## Planning Commission Staff Report

**SUBJECT:** Z13-12: REQUEST TO AMEND ORDINANCES NO. 1597 AND 1956 AND REZONE APPROXIMATELY 17.5 ACRES OF REAL PROPERTY WITHIN THE COPPER RANCH PLANNED AREA DEVELOPMENT (PAD), GENERALLY LOCATED SOUTH AND EAST OF THE SOUTHEAST CORNER OF WARNER AND RECKER ROADS FROM MULTI FAMILY-MEDIUM (MF-M) WITH A PLANNED AREA DEVELOPMENT (PAD) TO SINGLE FAMILY-DETACHED (SF-D) WITH A PLANNED AREA DEVELOPMENT (PAD) OVERLAY ZONING DISTRICT AND TO AMEND CONDITIONS OF DEVELOPMENT AS FOLLOWS: REDUCE LOT DIMENSIONS; DECREASE FRONT, SIDE AND REAR SETBACKS AND SEPARATION BETWEEN DWELLING UNITS; AND INCREASE THE MAXIMUM LOT COVERAGE FOR TWO AND THREE-STORY UNITS.

**Z13-12**

**Attachment 1: Notice of Public Hearing**

Z13-12  
Attachment 3: Parking Exhibit  
January 8, 2014

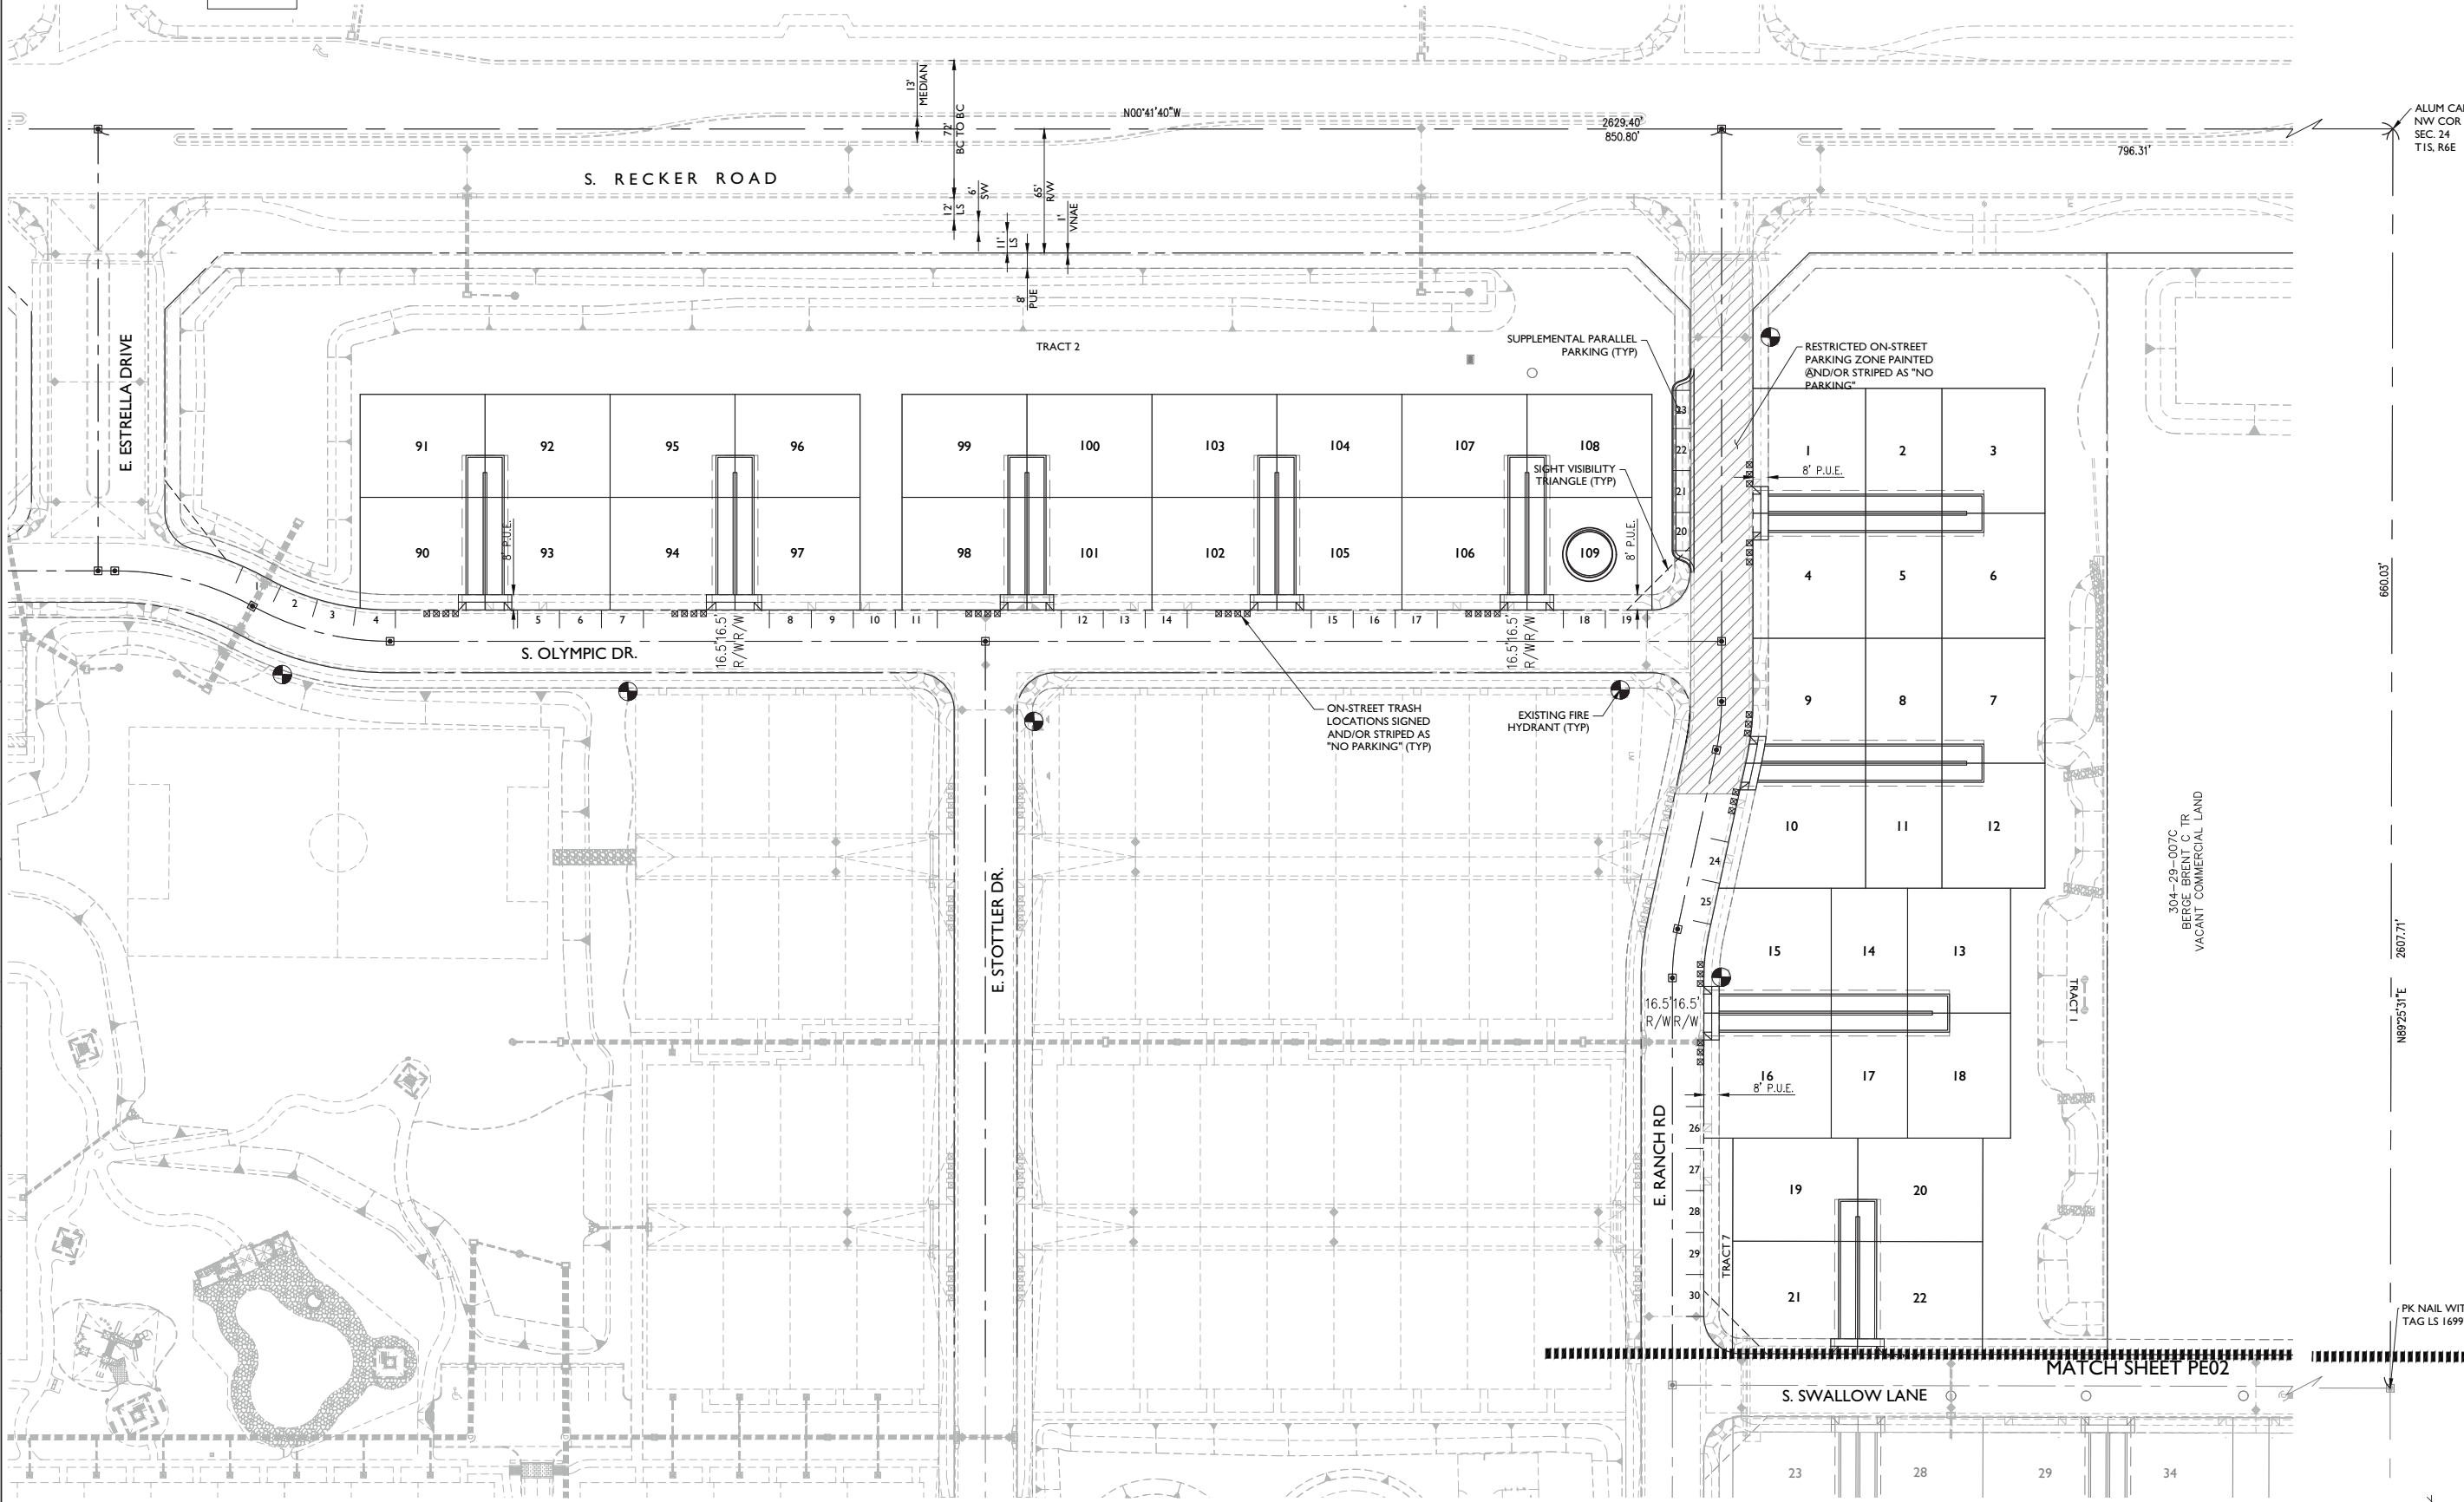
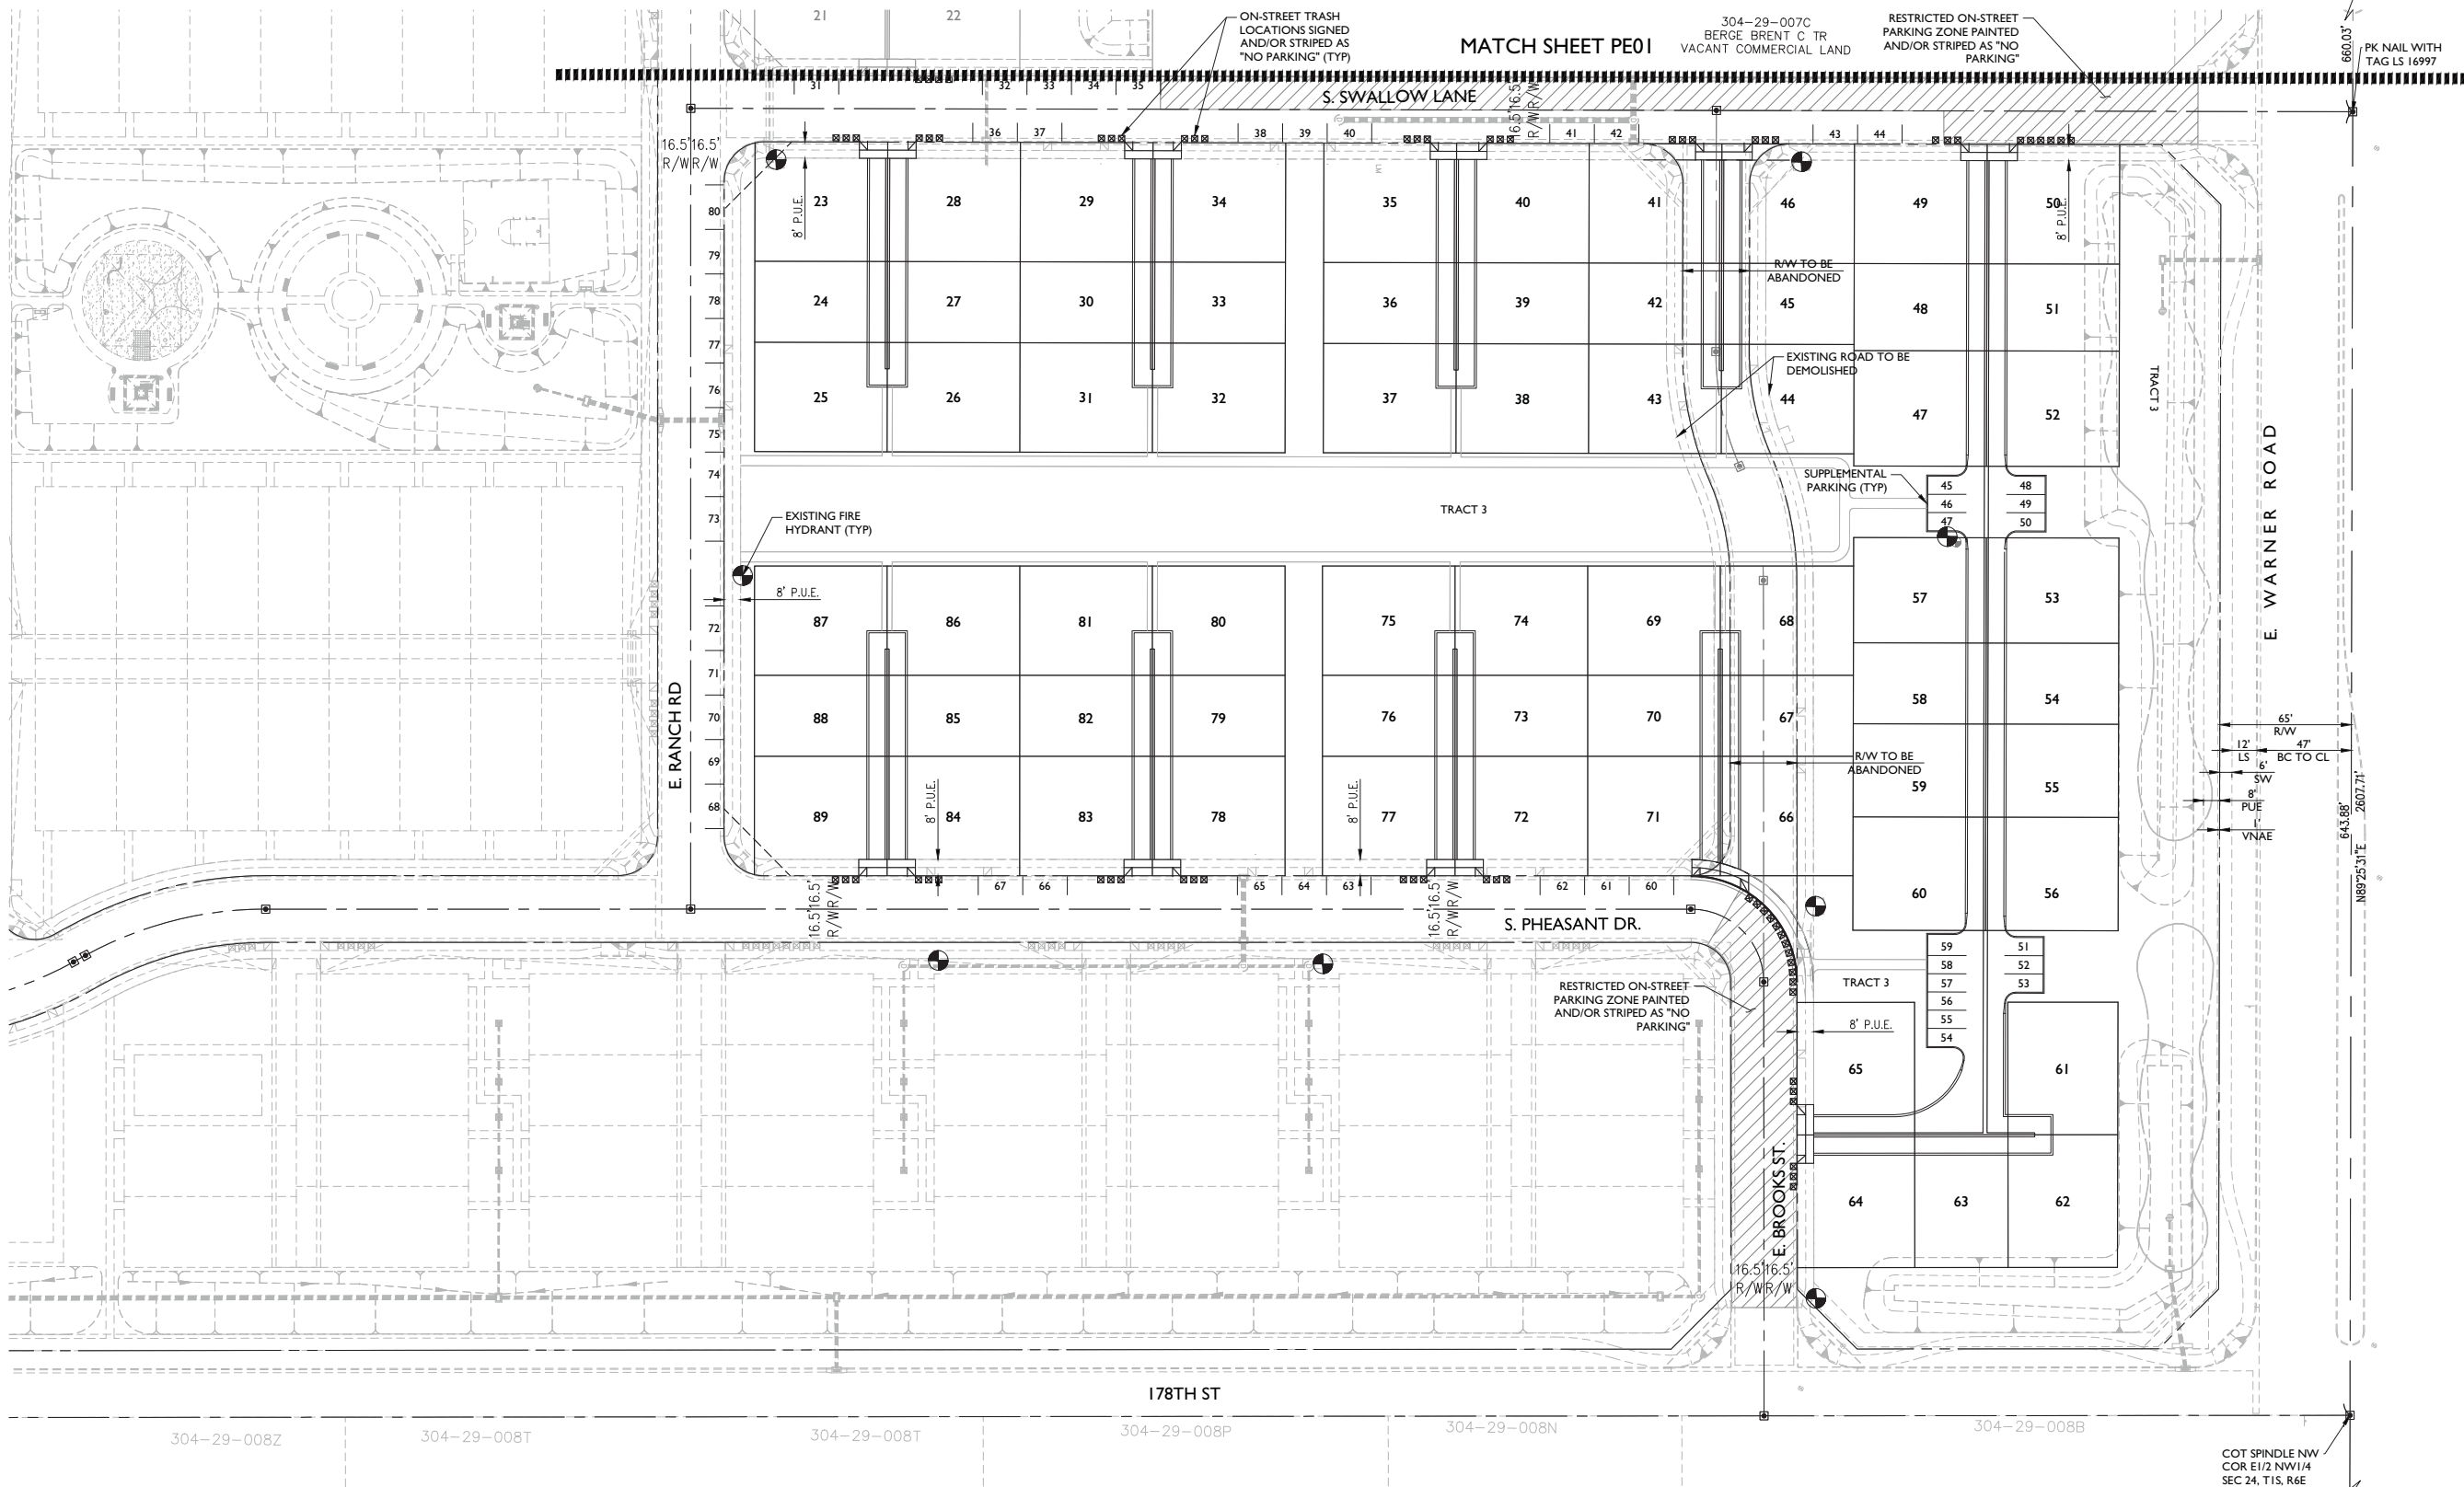
Since July, the applicant has produced several iterations of the Development Plan and parking exhibits to respond to the Planning Commission concerns and to the Traffic and Sanitation requirements regarding the functionality of the project. Because the proposed street design allows for on-street parking, there is not a requirement for guest parking per LDC Table 4.204. However, to address operational concerns, the applicant proposes to add 19 off-street parking spaces in four (4) separate off-street parking alcoves throughout the project in addition to the designated parallel on-street parking spaces.

The Traffic Division evaluated the last revision to the Development Plan proposed and states that the number of parking spaces (on-street parallel parking and off-street parking) as illustrated on the parking exhibit will allow acceptable operation; however, per the proposed subdivision layout, no additional pull-in parking would work because it would cause limited sight visibility and the difficulty of maneuvering around the parallel parked cars. Therefore, Sanitation, Traffic and Engineering Divisions have cautiously accepted the Development Plan proposal.
